STATE OF MAINE
DEPARTMENT OF TRANSPORTATION
16 STATE HOUSE STATION
AUGUSTA, MAINE 04333-0016

December 29, 2022
Subject: Acadia Gateway
State WIN: 017163.03
Location: Trenton
Amendment No. 3

ACADIA GATEWAY FACILITY

INTERMODAL AND WELCOME CENTER

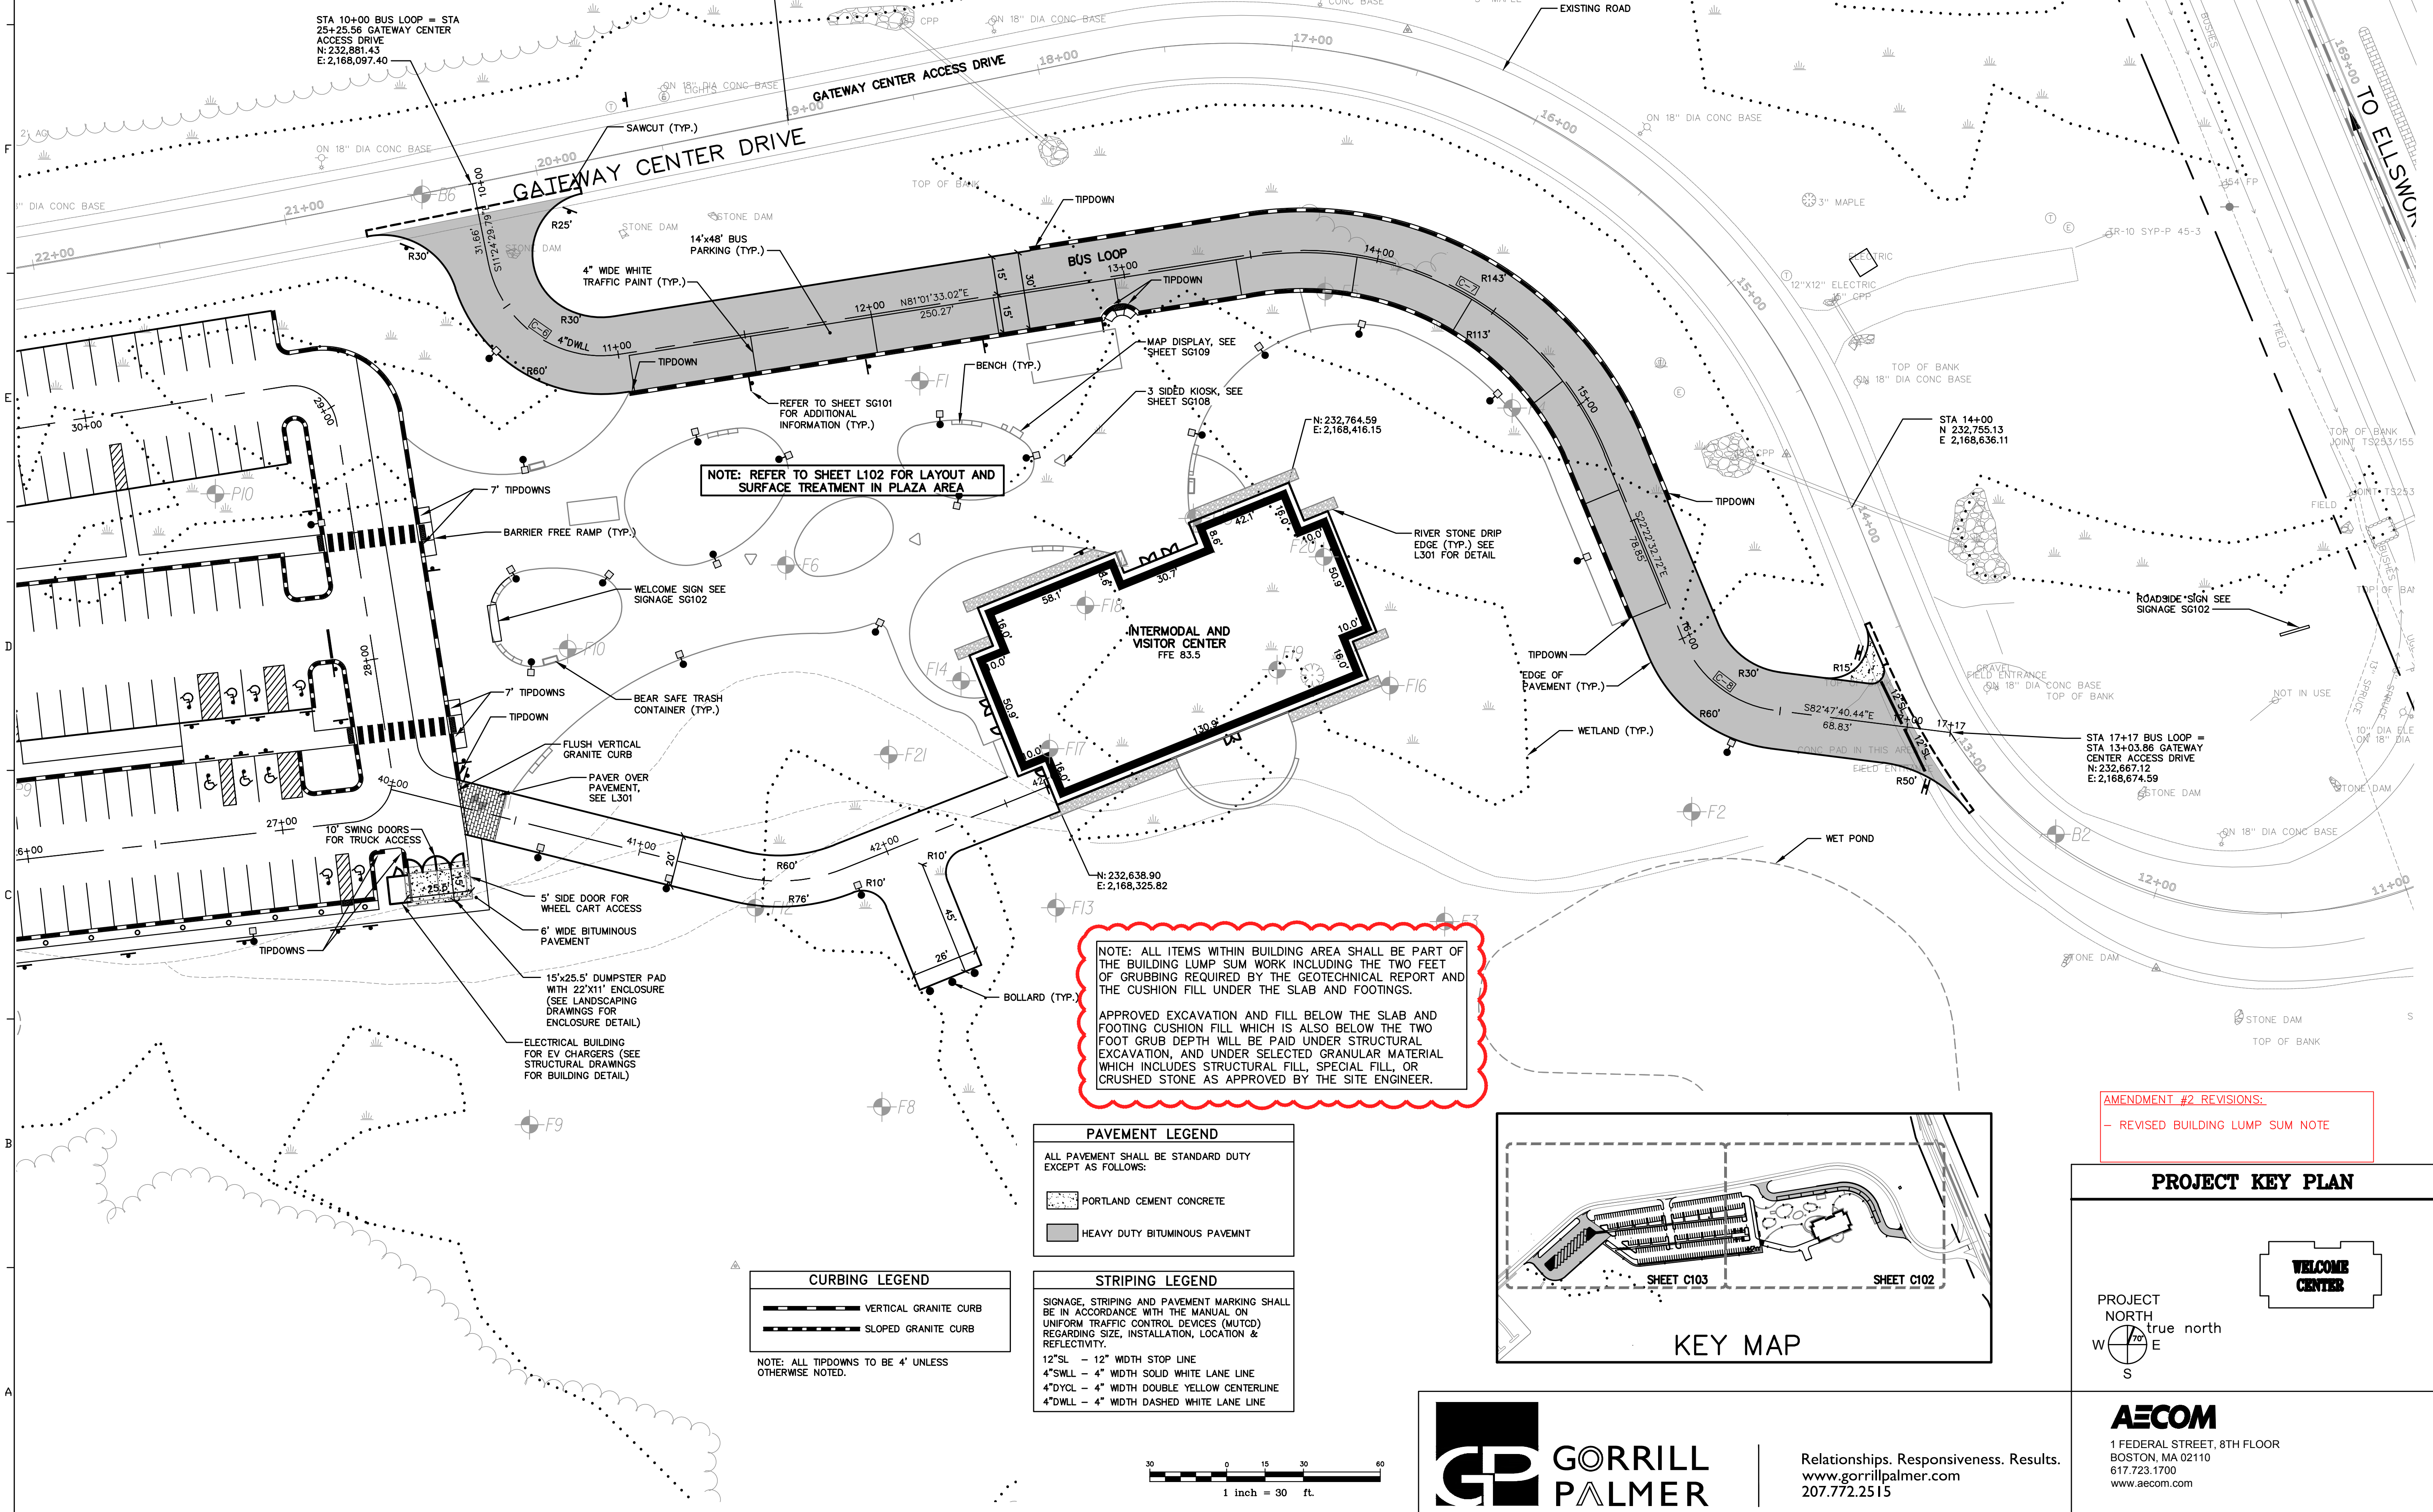
Question: Sheet C202 has a note block that states “all items within building area to be part of the building lump sum work”. Where in the specifications does it define the building area and what site work falls under that?

AMENDMENT #2 REVISIONS:
- REVISED BUILDING LUMP SUM NOTE

Response: Sheet C202 has been updated in Amendment #3 so that the note block states “NOTE: ALL ITEMS WITHIN BUILDING AREA SHALL BE PART OF THE BUILDING LUMP SUM WORK INCLUDING THE TWO FEET OF GRUBBING REQUIRED BY THE GEOTECHNICAL REPORT AND THE CUSHION FILL UNDER THE SLAB AND FOOTINGS. APPROVED EXCAVATION AND FILL BELOW THE SLAB AND FOOTING CUSHION FILL WHICH IS ALSO BELOW THE TWO FOOT GRUB DEPTH WILL BE PAID UNDER STRUCTURAL EXCAVATION, AND UNDER SELECTED GRANULAR MATERIAL, WHICH INCLUDES STRUCTURAL FILL, SPECIAL FILL, OR CRUSHED STONE, AS APPROVED BY THE SITE ENGINEER.”

NOTE: ALL ITEMS WITHIN BUILDING AREA SHALL BE PART OF THE BUILDING LUMP SUM WORK INCLUDING THE TWO FEET OF GRUBBING REQUIRED BY THE GEOTECHNICAL REPORT AND THE CUSHION FILL UNDER THE SLAB AND FOOTINGS. APPROVED EXCAVATION AND FILL BELOW THE SLAB AND FOOTING CUSHION FILL WHICH IS ALSO BELOW THE TWO FOOT GRUB DEPTH WILL BE PAID UNDER STRUCTURAL EXCAVATION, AND UNDER SELECTED GRANULAR MATERIAL WHICH INCLUDES STRUCTURAL FILL, SPECIAL FILL, OR CRUSHED STONE AS APPROVED BY THE SITE ENGINEER.

OVERALL UTILITY PLAN

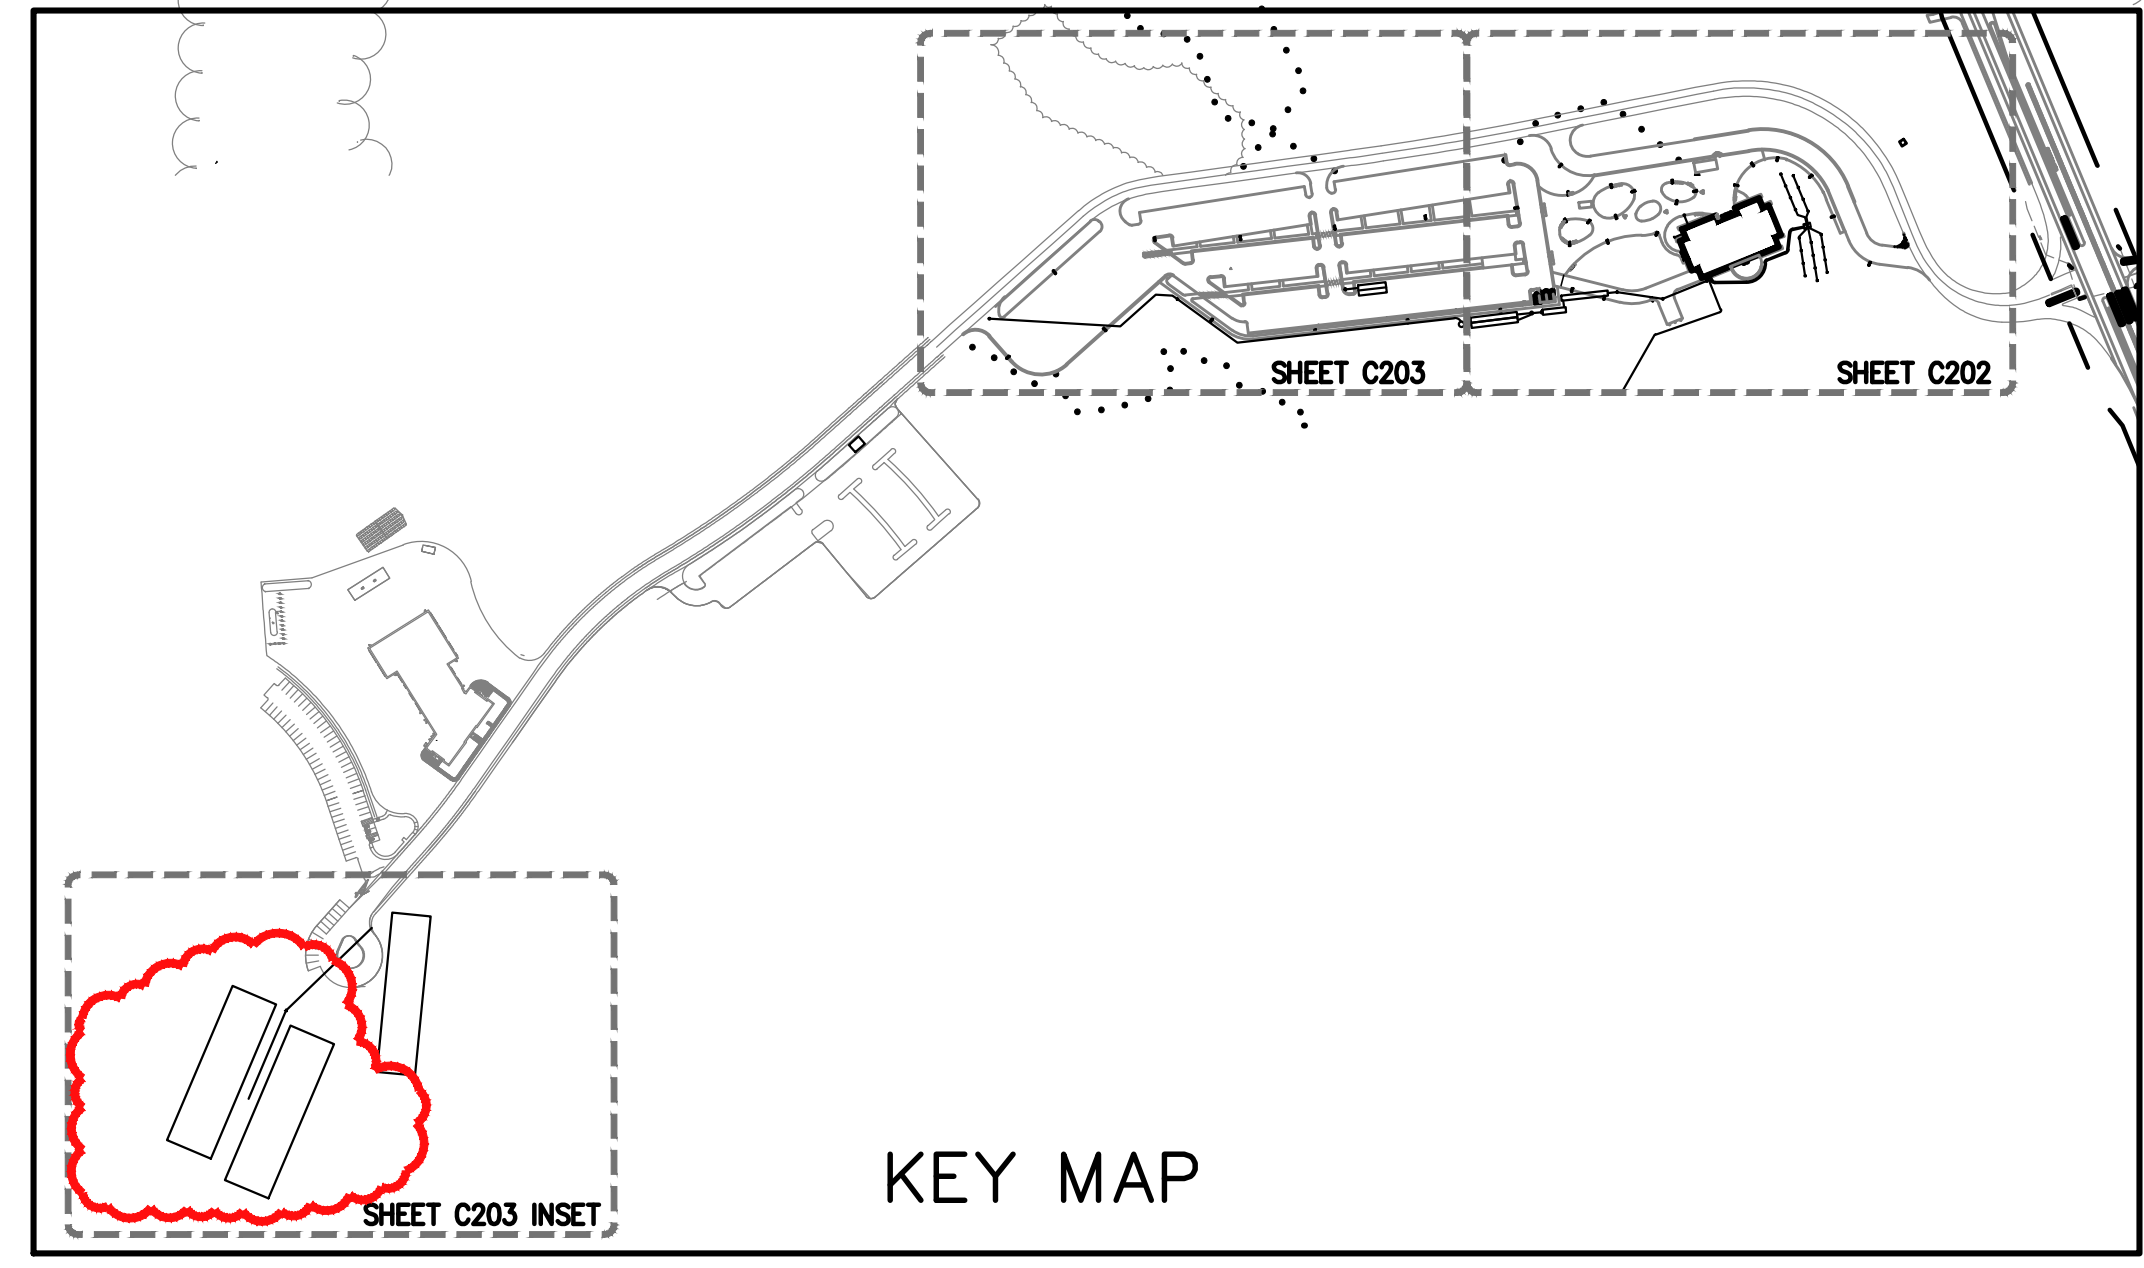
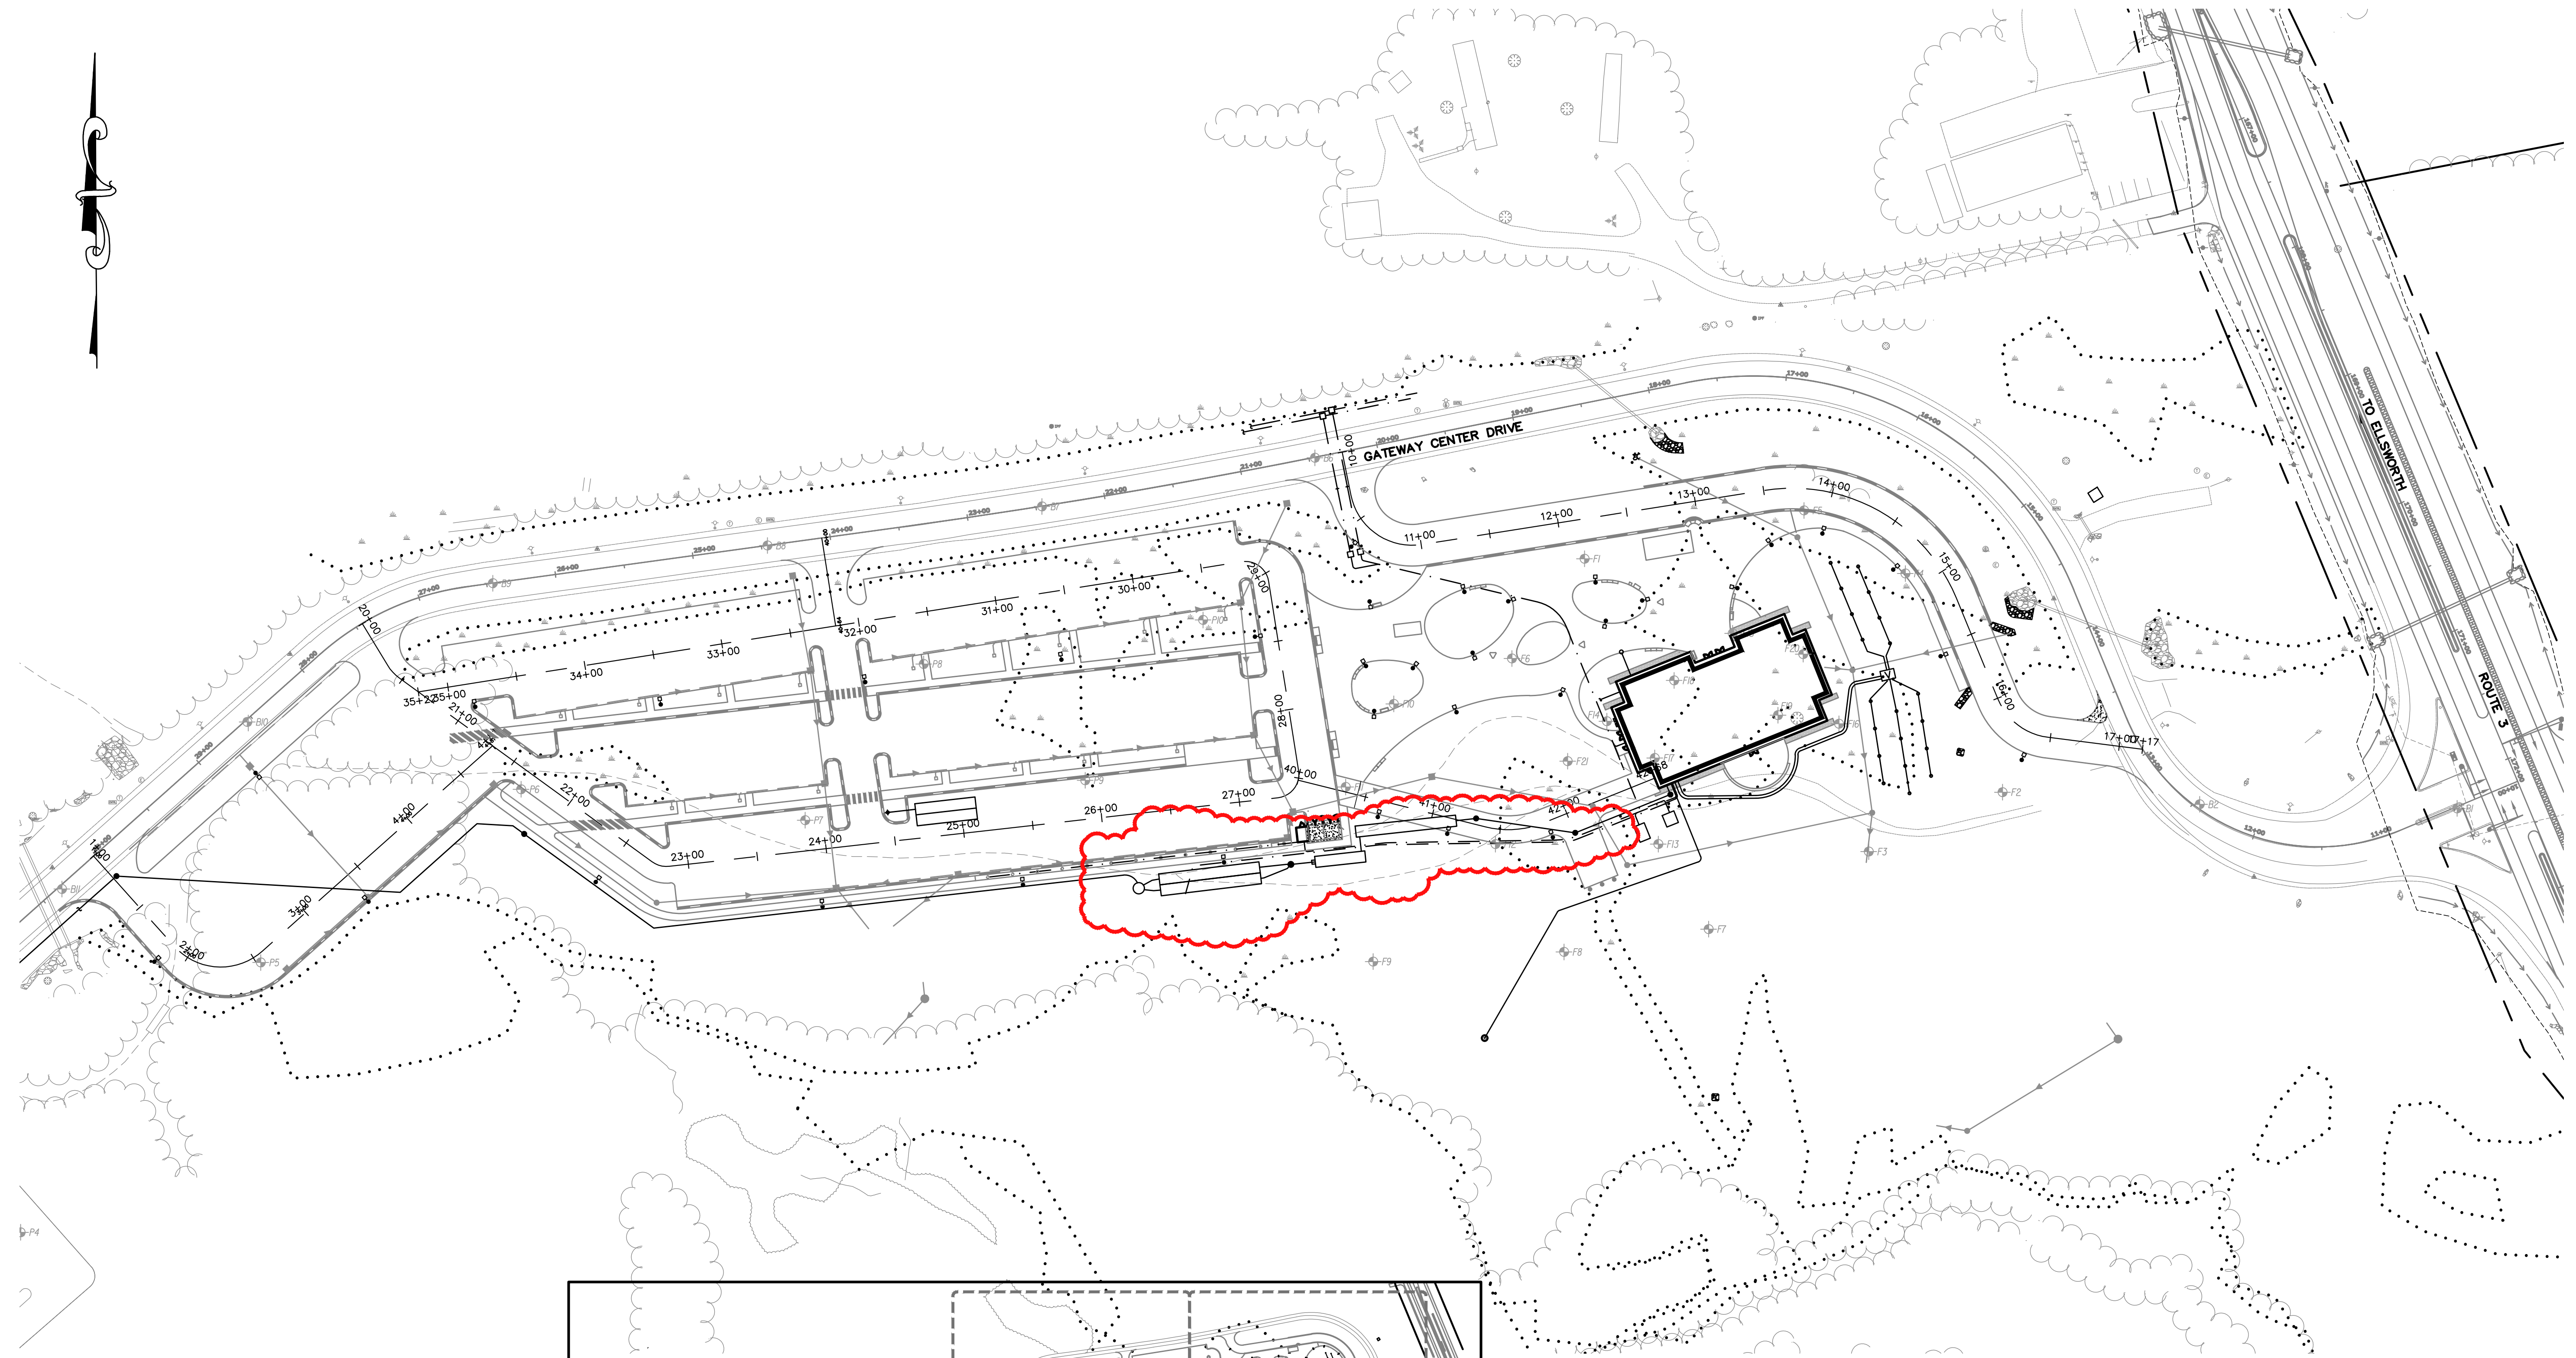
AMENDMENT #2 REVISIONS:
 - REVISED SEPTIC TANK AND TREATMENT UNITS LAYOUT & PIPE NETWORK
 - UPDATED SEPTIC FIELD DESIGN
